SERVICE DIRECTIVE BULLETIN NO. 0106

1. SUBJECT: Main Rotor Pitch Change Bellcranks Missing Chamfers
2. MODEL: F-28A, F-28C, F-28F, 280, 280C, 280F, and 280FX
3. EFFECTIVITY: All serial numbers
4. BACKGROUND:

Figure 1. Chamfer on the inboard ear – two places

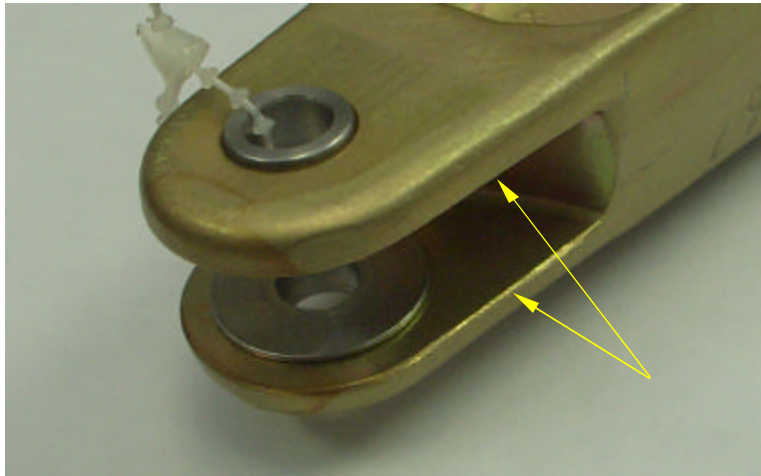
Enstrom has become aware of three (3) Pitch Change Bellcranks (Bellcranks), P/N 28-14207-101, that are missing chamfers on the bottom of the inboard ears. The missing chamfers do not create a Safety of Flight issue; however, the chamfers are required in accordance with (IAW) the FAA Approved Engineering Data.

- A. Using a suitable light source and inspection mirror or by disconnecting the pitch change bellcranks from the main rotor control rods and attachment bracket, inspect the bottom of the inboard ears for a .02” - .04” X 45° / 0.5 mm – 1.0 mm X 45° chamfer (refer to Figure 1). If chamfers are not on the Bellcrank(s), rework the Bellcrank(s) to add the chamfers IAW paragraph 5.2. If the chamfers are on the Bellcranks, reinstall the Bellcranks and return the aircraft to service.

Figure 2. Dimensional data for chamfer application

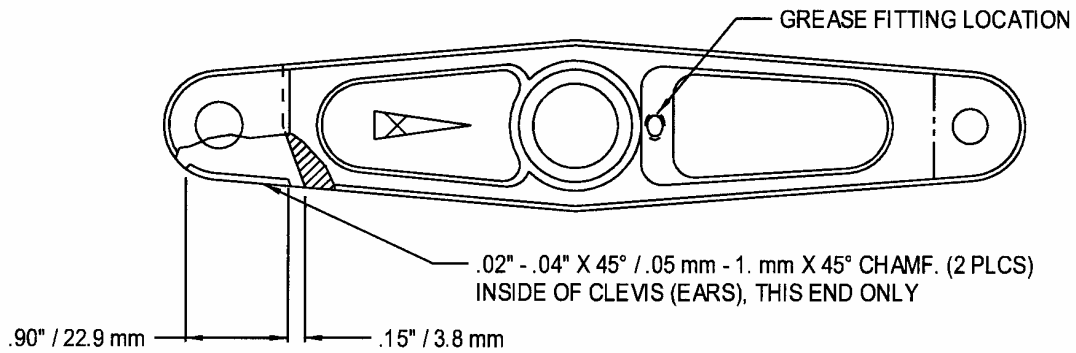
- A. Remove the Pitch Change Bellcranks from the helicopter following the procedures in the applicable maintenance manual.
- B. Using a small file or other suitable device, add a .02” - .04” X 45° / 0.5 mm – 1.0 mm X 45° chamfer to both sides of the bottom inboard ear (refer to Figure 2). Apply a protective coating of epoxy primer (Desoto #593 X 300 or equivalent) to the reworked area.
- C. Reinstall the Pitch Change Bellcranks following the procedures in the applicable maintenance manual and return the aircraft to service.

NOTE: BLEND ENDS OF CHAMFER INTO ADJACENT MATERIAL
